City of Albuquerque

RE: ARCADIA HOMES (K17-D84). GRADING AND DRAINAGE PLAN FOR PAVING PERMIT APPROVAL. ENGINEER'S STAMP DATED JANUARY 9, 2000.

Based on the information provided on your submittal of January 10, 2000, the above referenced project is approved for Paving Permit.

PROPOSED PAVING PLAN

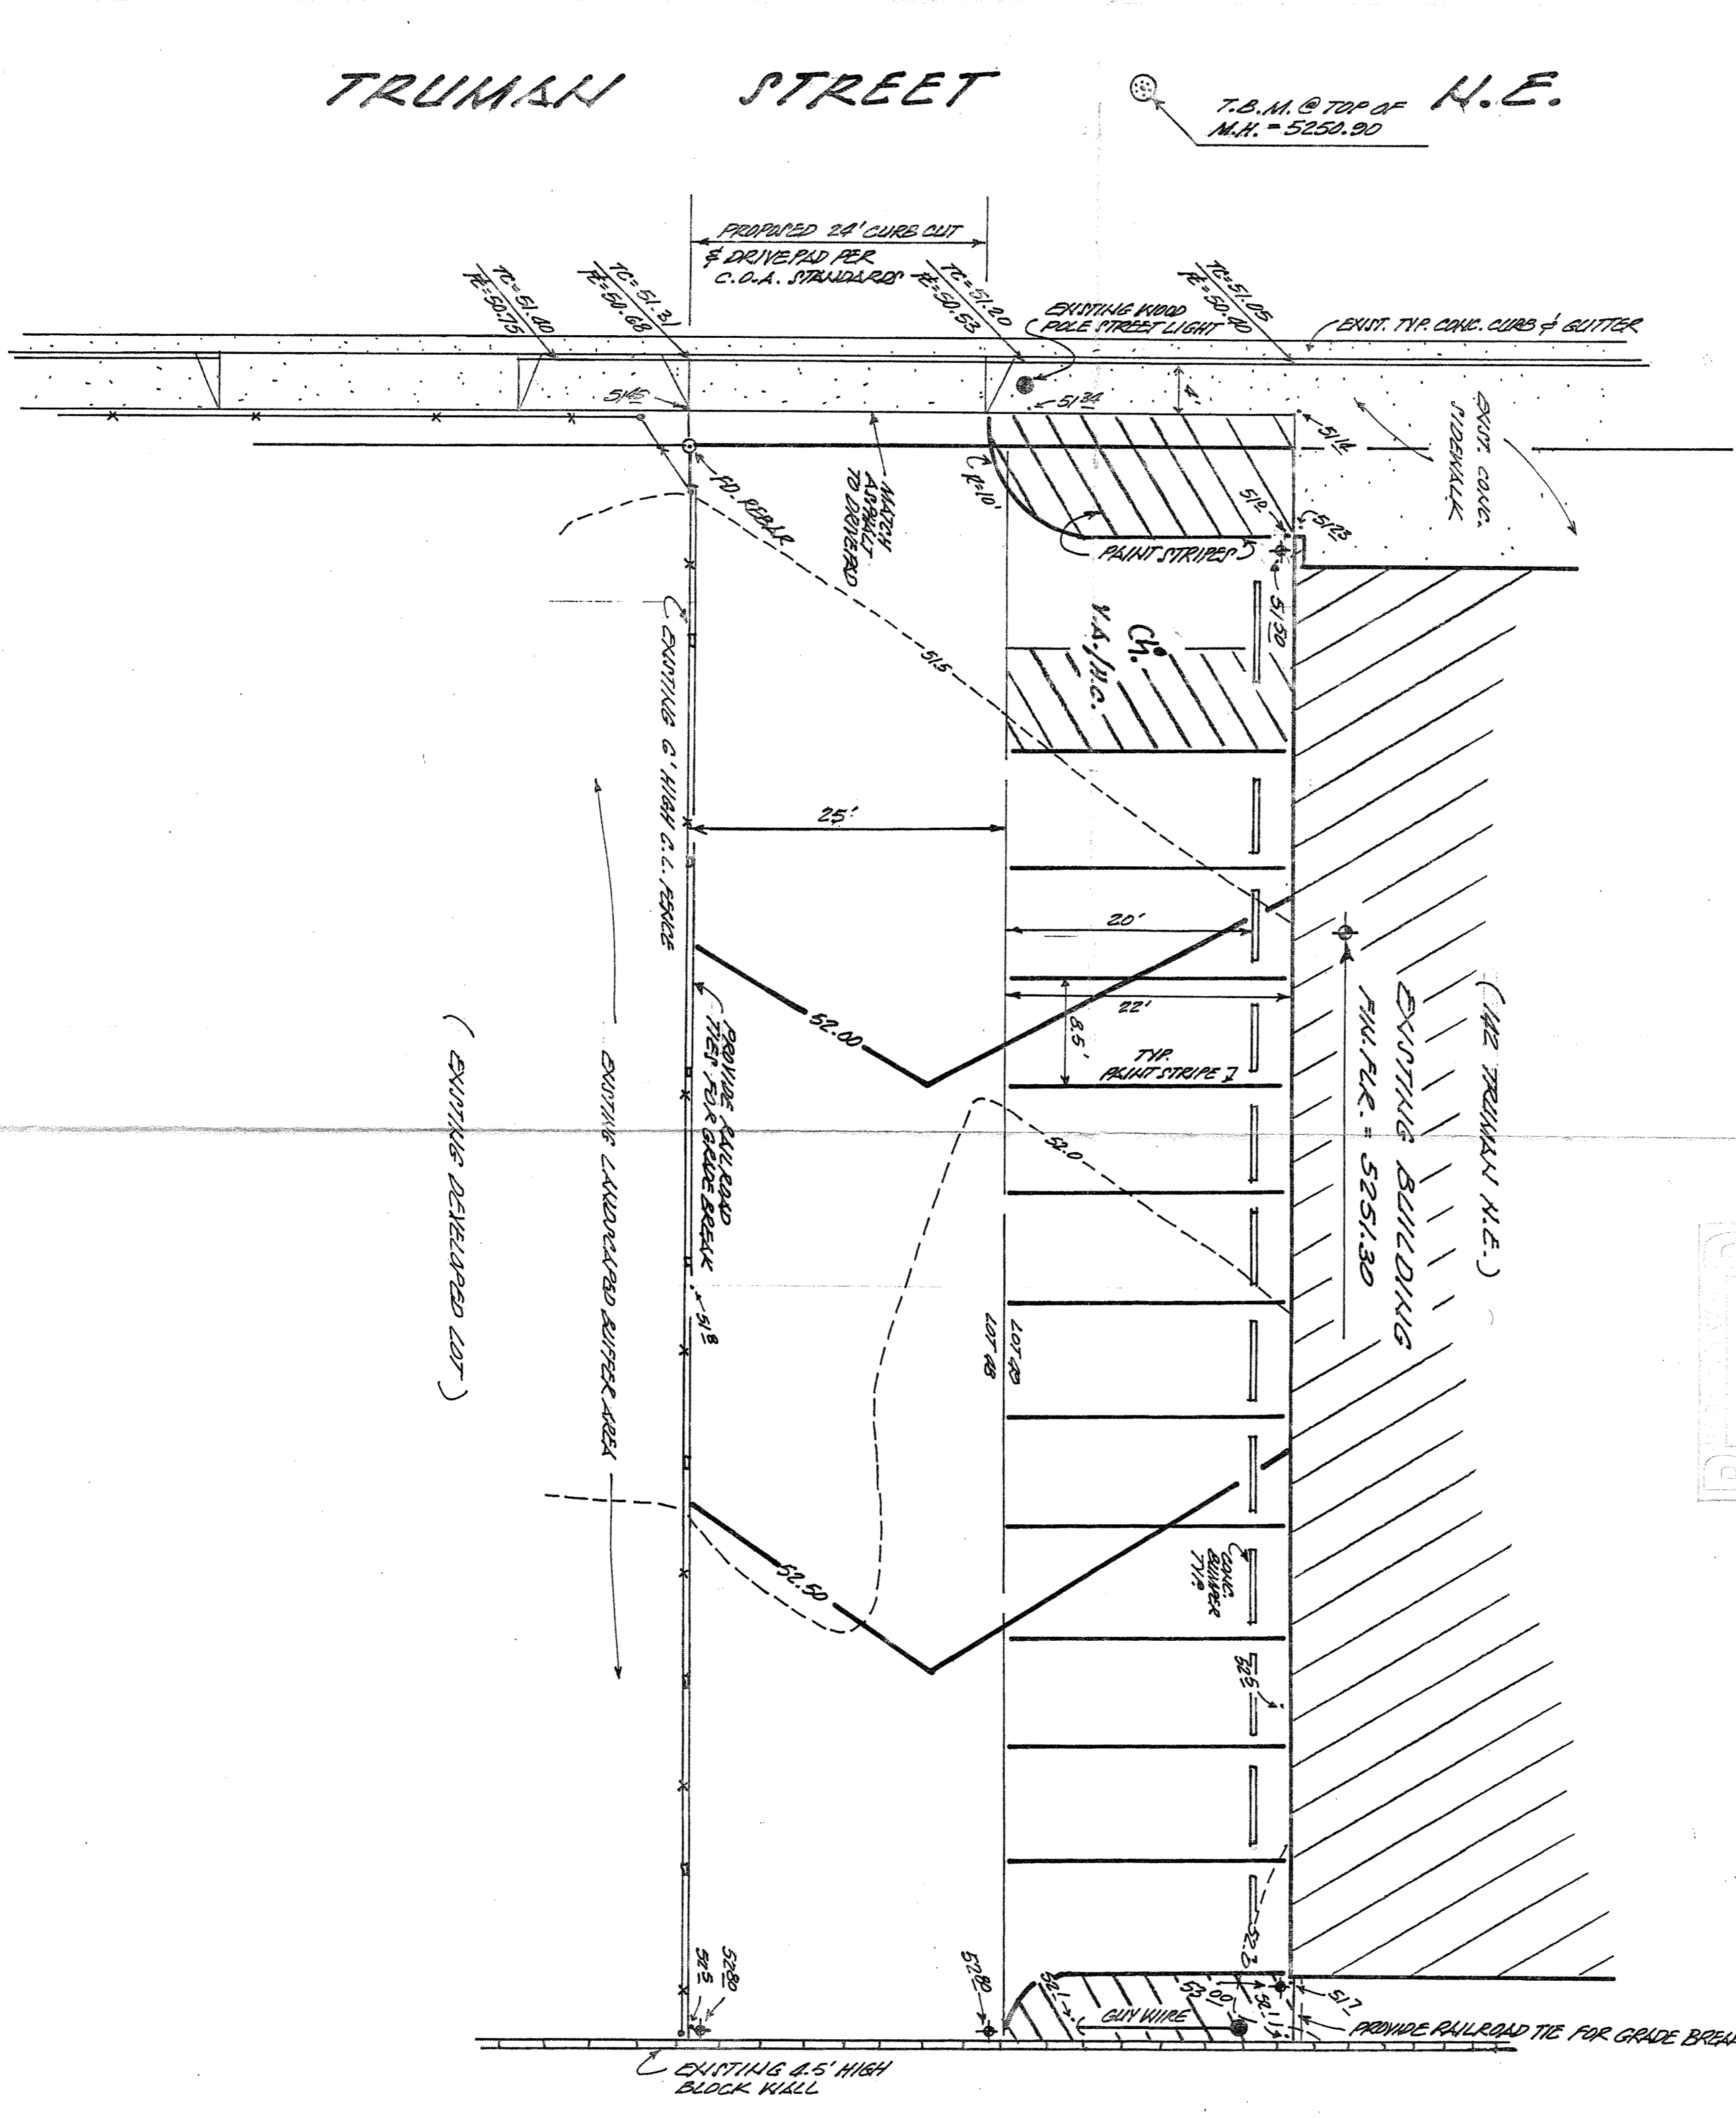
Transportation has commented this date on the T.C.L. The G&D Plan and the Site Plan (T.C.L.) should be congruous.
